**STAFF REPORT AND RECOMMENDATION TO THE LANDMARKS COMMISSION**

CASE FILE: LU 17-158467 HRM- Mt. Tabor Yard  
PC # 16-214771

**NOTE: THIS REPORT RECOMMENDS APPROVAL WITH CONDITIONS. THIS STAFF REPORT IS REVISED FROM THE STAFF REPORT DATED DECEMBER 11, 2017. CHANGES ARE UNDERLINED.**

CONCEPTUAL ART CONFIGURATION #4

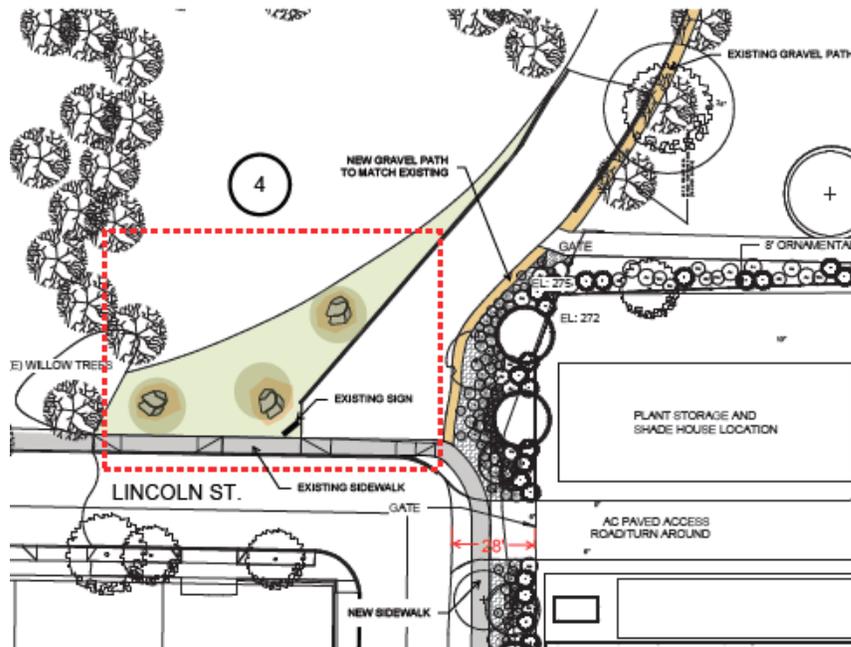
- A substantial 15’ deep L3 high screen landscape buffer has been provided along the west edge in order to visually screen the green houses and also define the south entrance to the park. A 5’ deep L3 landscape buffer, minus the tree requirement, wraps around the north fence adjacent to the gravel pathway to help screen the actively used park on the north from the horticultural structures.
- The public art plan now includes a fourth location for either public art installation or significant landscaping, as part of future improvements in the island at the northwest corner of the intersection of Lincoln Street and the south entrance to the park. This will help define and act as a gateway to the south park entrance. (Exhibit C.44; [Drawing A-9 in Commission packet](#)) The following condition of approval is included to ensure this provision:

H. Public art or significant landscaping will be installed at the south entrance of Mt. Tabor Parks, near the intersection of SE Lincoln Street and SE 65th Avenue as shown in Exhibit C-44, during the next phase of the Parks Master Plan implementation.

**EAST ELEVATION**  
 SCALE: 3/64" = 1'-0"  
 If print on 11" X 17" sheet

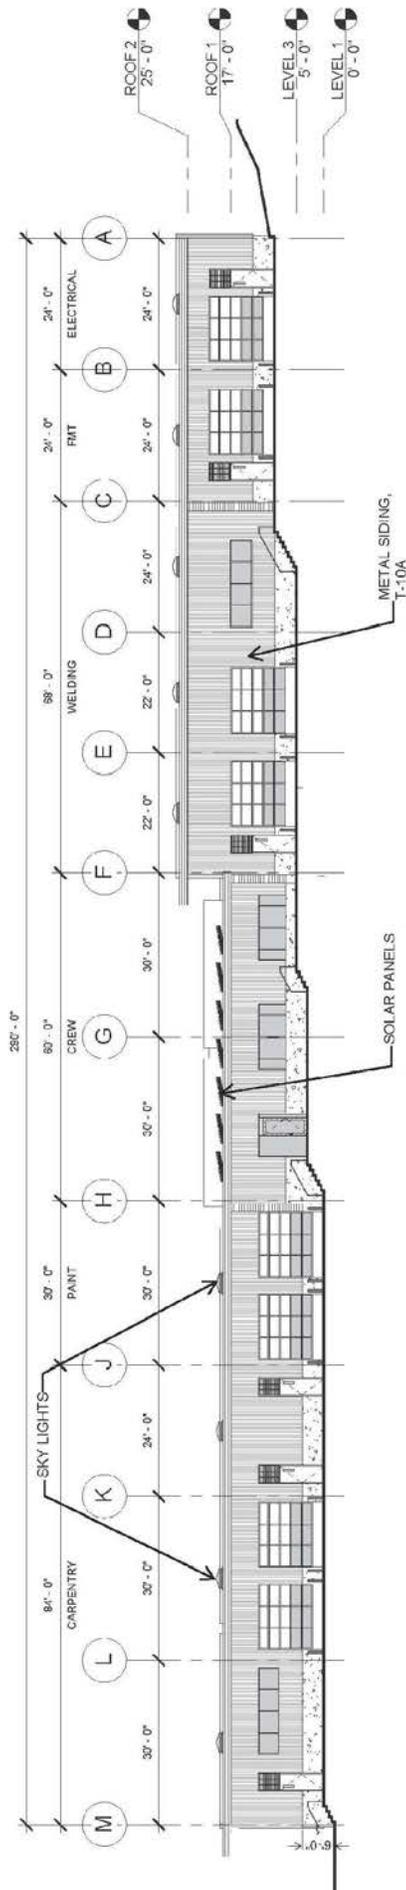
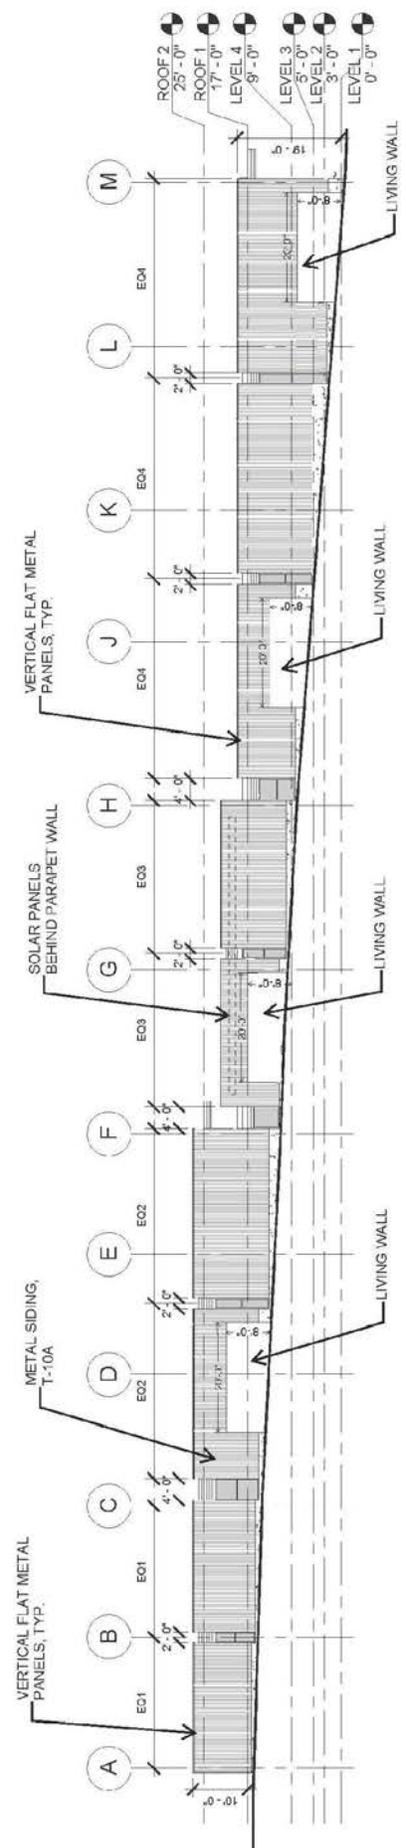
- The proposed simple and modern design is appropriate for the utilitarian nature of the building.
  - The building design reflects a hierarchy of use, with a more transparent east façade with multiple garage openings facing the yard and a more solid west façade for the rear of the building. This is consistent with many historic buildings whose rear facades are devoid of detail.

- The simple west elevation serves as a backdrop and showcases the landscaping in the building setback.
  - The overall landscape design along the new multi-modal pathway, including along the west elevation, provides a strong unifying feature and the contextual response to the rest of the historic district. This is discussed in greater detail below.

- The niches include wood detailing above the window that carry through to the parapet. Wood detailing has also been provided for the parapet edge on the east and south elevations, with narrow vertical wood sections running down the east elevation. These add a natural wood aesthetic to the utilitarian building, which would be consistent with its park setting.

- Narrow vertical flat metal panels, approximately 5" wide, are proposed at intervals within each façade and serve to scale down and provide a rhythmic progression along the pathway.
